Tuen Mun - Chek Lap Kok Link
Northern Connection Sub-sea Tunnel Section
Contract No. HY/2012/08

T	M	C	L	K	L	8	-	D	B	J	-	G	E	N	-	R	E	P	-	9	8	7	4	5	-	A	IFA
Project Ref. Num.						issuer			Location			Doc. Type			Doc. Sequential. Num.			Rev.	Status.

Environmental Assessment
Changes in Dredging Extent of Northern Landfall

Figure 1 Latest Construction Sequence

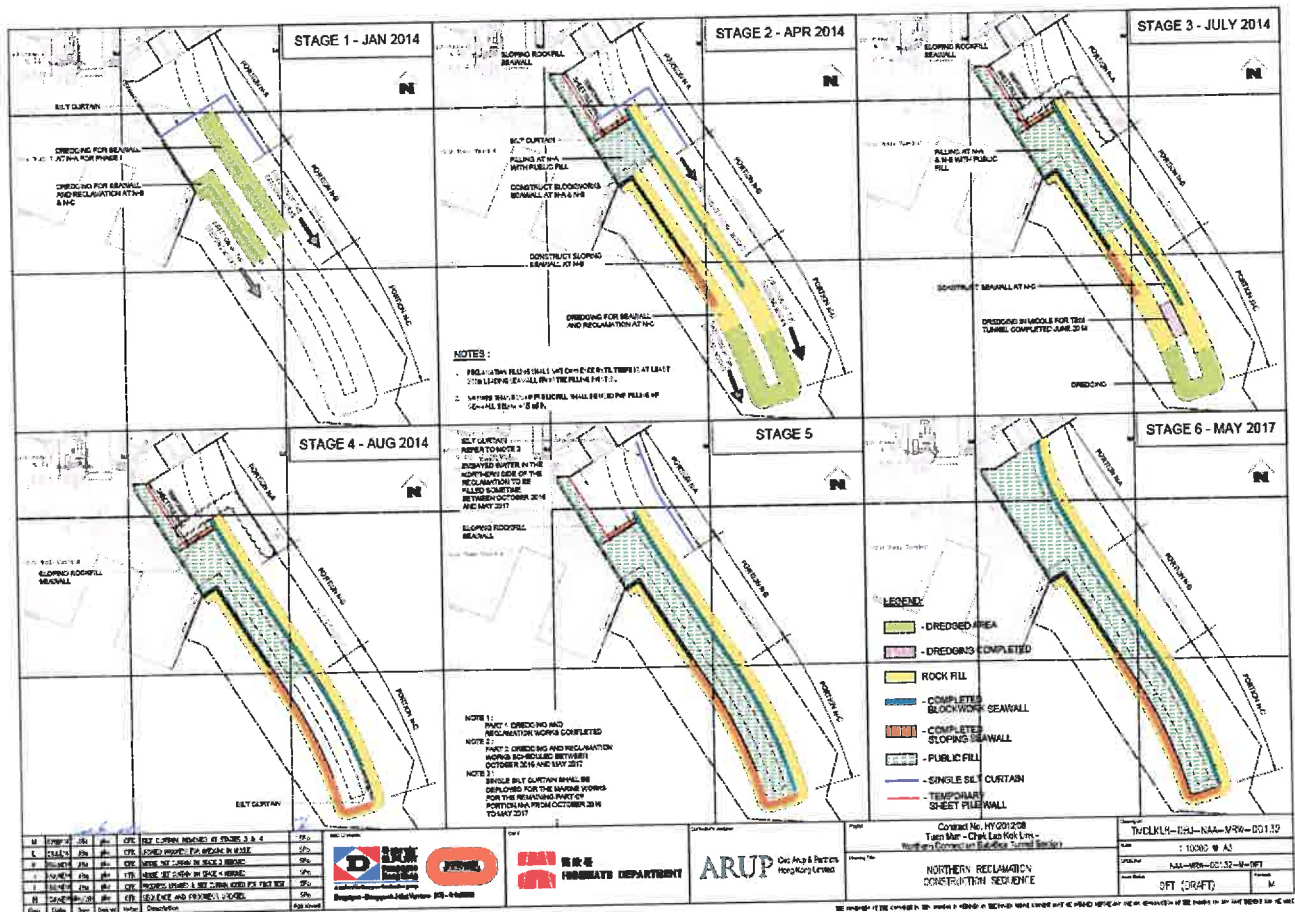
Pursuant to Condition 3.5 of the Environmental Permit EP-354/2009/B, we hereby give written notice that, due to changes in progress and methodology, “dredging in the middle” at Portions N-A and N-B, as specified under Condition 3.7(d) and Figure 3 of the EP-354/2009/B is no longer necessary. The latest construction sequence is illustrated in Figure 1 and Appendix A.

It is proposed that the dredging in the middle of Portion N-A and Portion N-B to be deleted. The additional dredging in the middle of Portions N-A and N-B, as stated under VEP application (VEP-426/2014) and subsequently approved in the EP-354/2009/B, was intended to resolve buoyancy pressure of marine mud acting upon the TBM assembly, as well as other geotechnical and structural limitations.

An alternative solution of ground treatment will be implemented to speed up consolidation of the Northern Landfall, so that the TBM may safely drill through it. This solution involves the use of vibrocores. This method employs large vibrating rod, which vibrates into the ground to compact the wet soil. In the process, additional sand is pulled down to the ground, filling voids and forming compacted land. Once the land is compacted, drilling rigs will plow/drill into the ground at strategic locations to inject and mix cement grout into the soil. This will further bind the fill material and solidify the grounds to provide a stabilized substrate for the TBM to drill through, avoiding buoyant pressure acting upwards on the TBM unit.

The ground treatment works is land-based. It replaces the marine dredging works in the middle of Portions N-A and N-B and is carried out on top of the completed parts of the Northern Landfall reclamation. Therefore, it is considered that the reclamation method, as considered under the EIA assumption, will not change as a consequence of the proposed changes.

NORTHERN RECLAMATION
CONSTRUCTION SEQUENCE

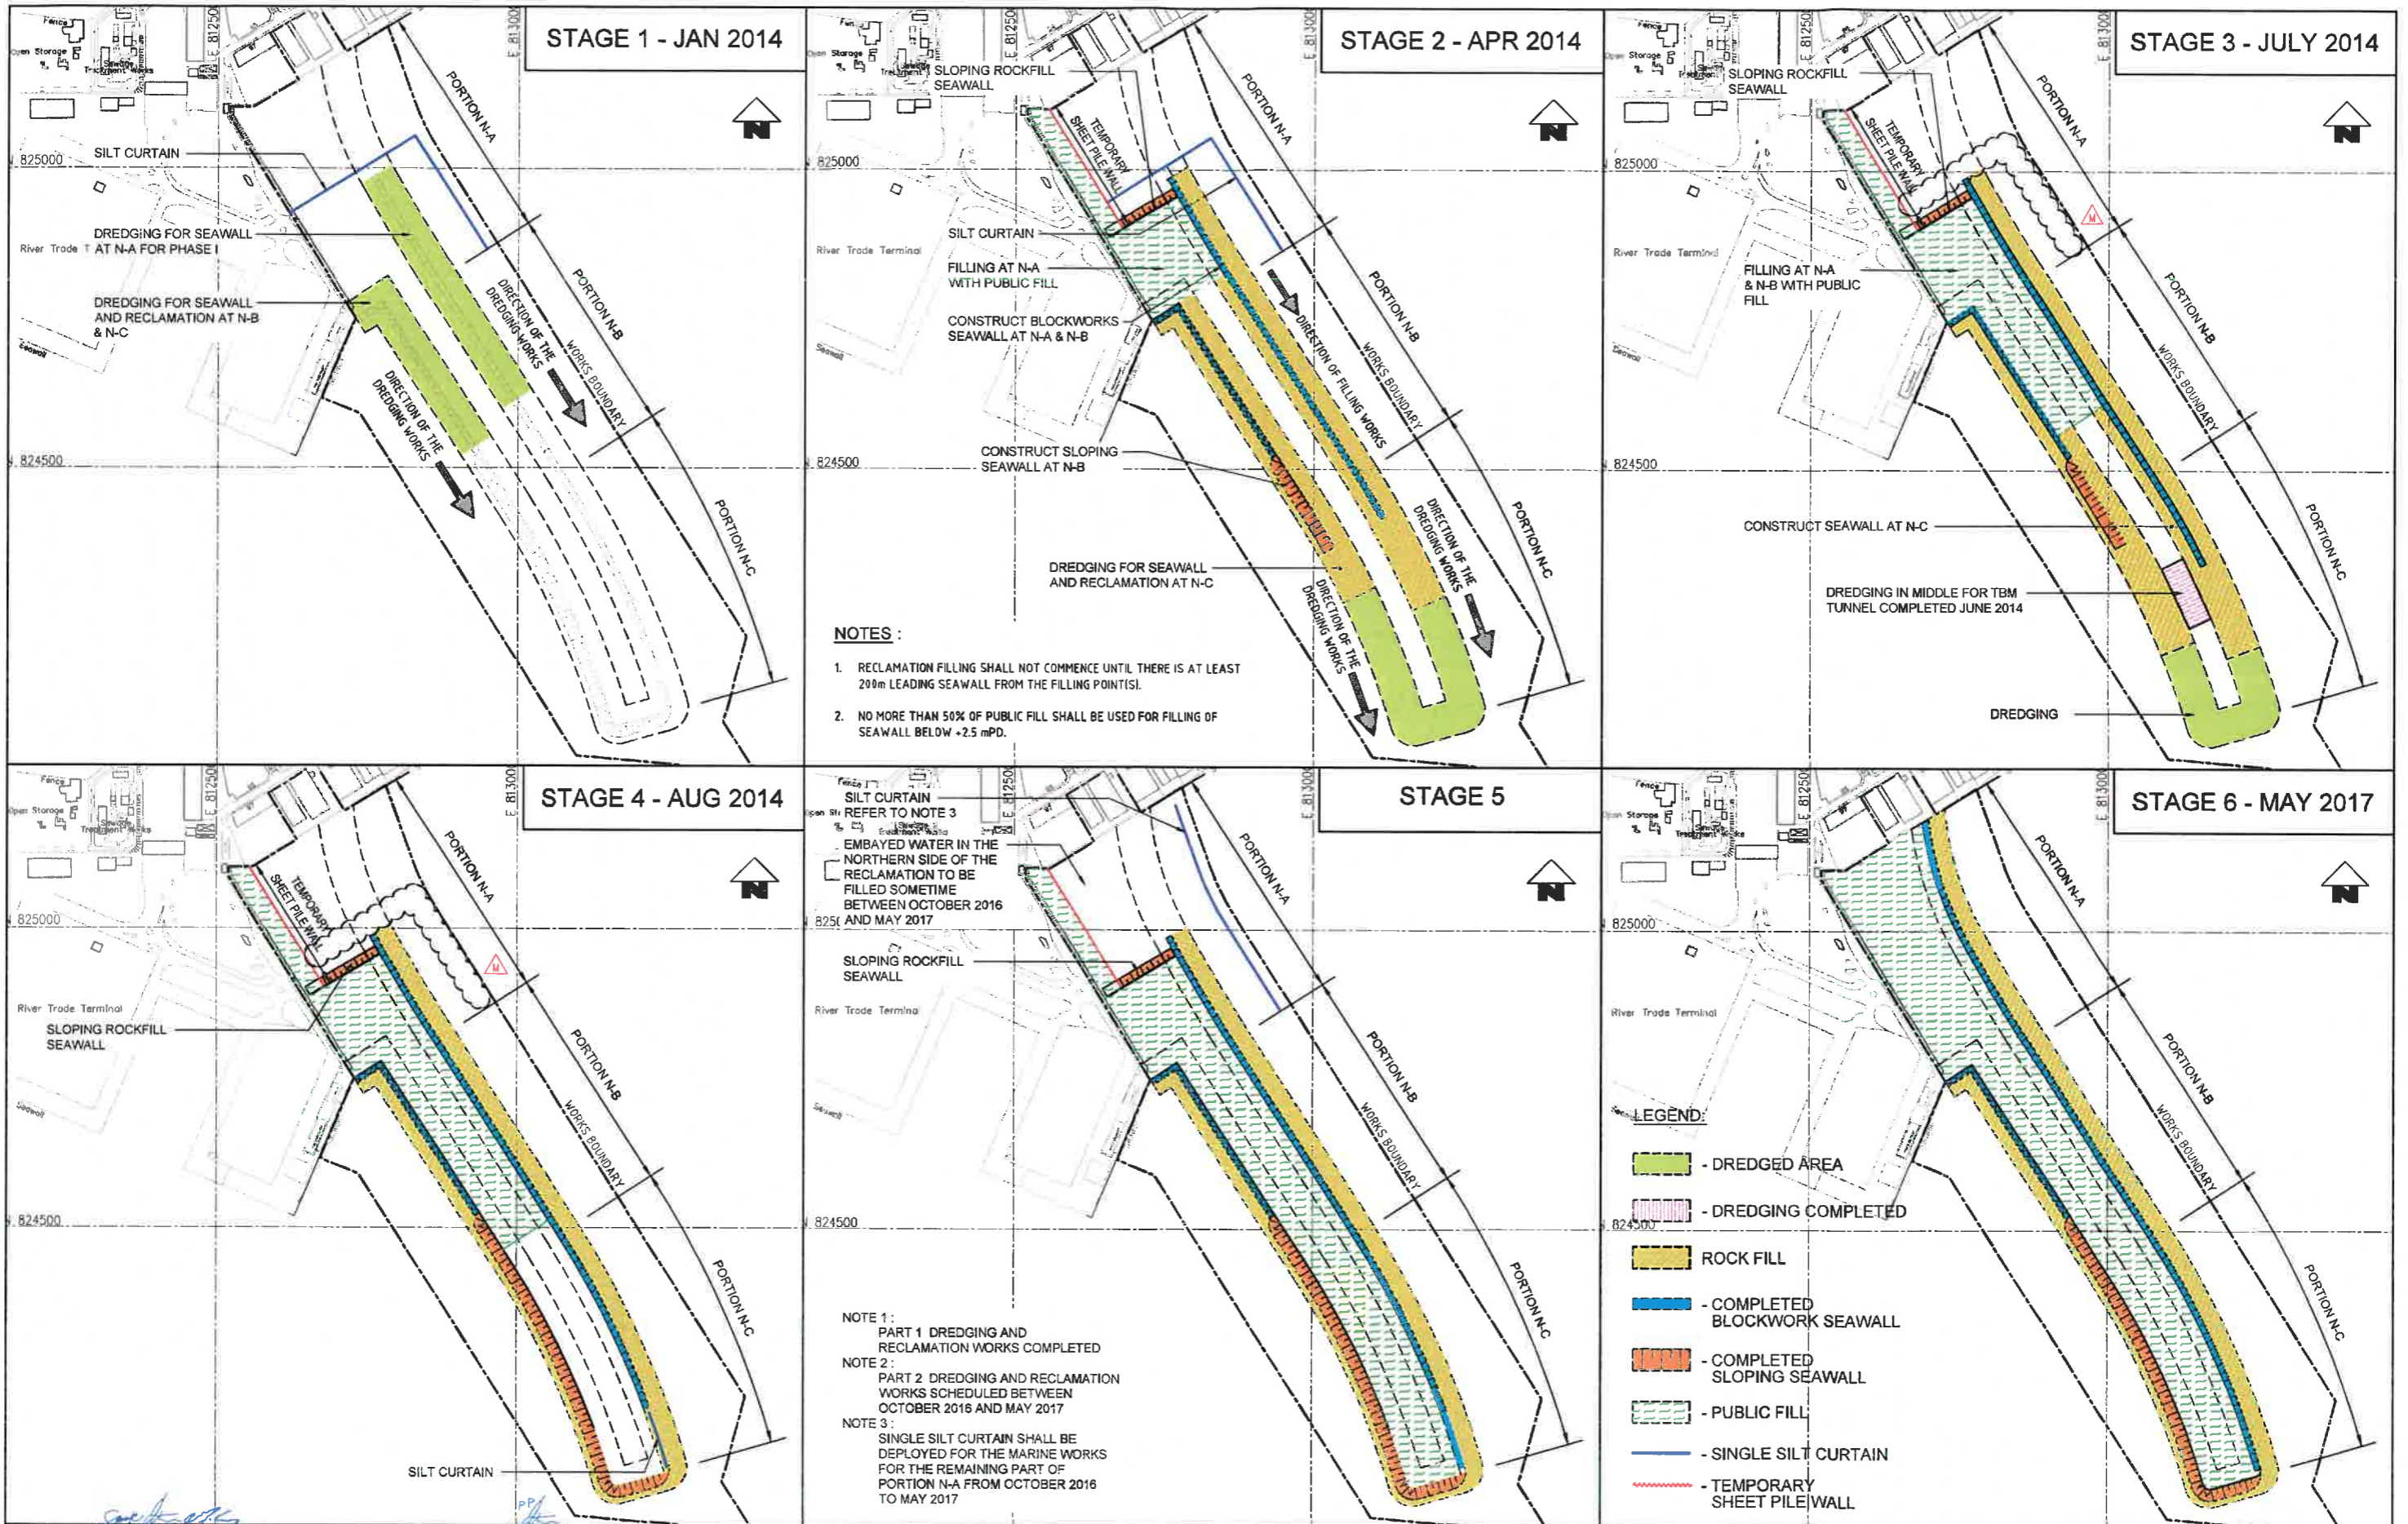
M	02SEP14	JBU	pkv	CFK	SILT CURTAIN REMOVED AT STAGES 3 & 4	SPo
L	09JUL14	JBU	pkv	CFK	UPDATED PROGRESS FOR DREDGING IN MIDDLE	SPo
K	26JUNE14	JBU	pkv	CFK	MIDDLE SILT CURTAIN ON STAGE 3 REMOVED	SPo
J	23JUNE14	JBU	pkv	CFK	MIDDLE SILT CURTAIN ON STAGE 4 REMOVED	SPo
I	19JUNE14	JBU	pkv	CFK	PROGRESS UPDATED & SILT CURTAIN ADDED FOR PILOT TEST	SPo
H	10JUNE14	pkv/JBU	pkv	CFK	SEQUENCE AND PROGRESS UPDATED	SPo
Rev.	Date	Drawn	Designed	Verified	Description	Approved
